TOWN OF KEENESBURG  
PLANNING COMMISSION MEETING  
THURSDAY, AUGUST 6, 2020, 6:00 P.M.  
KEENESBURG TOWN MEETING HALL  
140 SOUTH MAIN STREET, KEENESBURG, CO 80643

1. Call to order
2. Pledge of allegiance
3. Roll Call
4. Public Comments
5. Approval of Minutes for July 9, 2020 and July 16, 2020
6. New Business
  - a. PUBLIC HEARING: To Consider a preliminary and final plat for the RK Subdivision consisting of 15.06 acres divided into 7 lots

**PROJECT:** RK Subdivision Preliminary and Final Plan

SITE PLAN  
ROBERTSON -KAISER ANNEX  
PRELIMINARY PLAT  
TOWN of KETNESBURG, WELD COUNTY, COLORADO

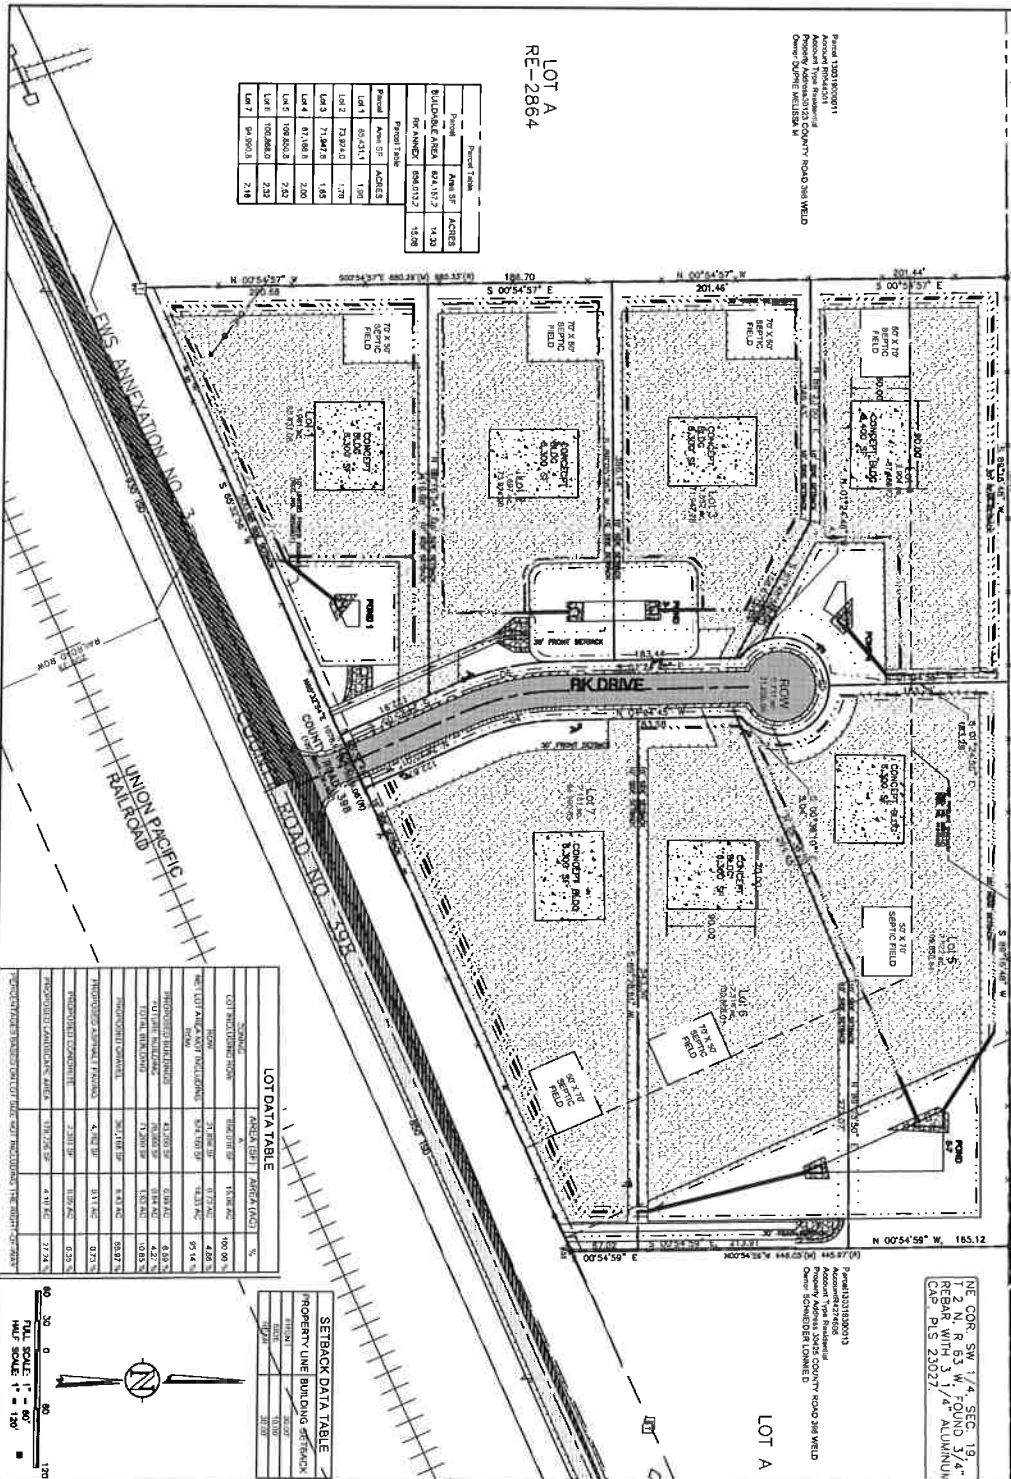
4. The Site Plan, Sheet 4, should depict how access to Lots 1 and 4 will be achieved. Both lots have storm drainage ponds and swales that cover the lot frontage.
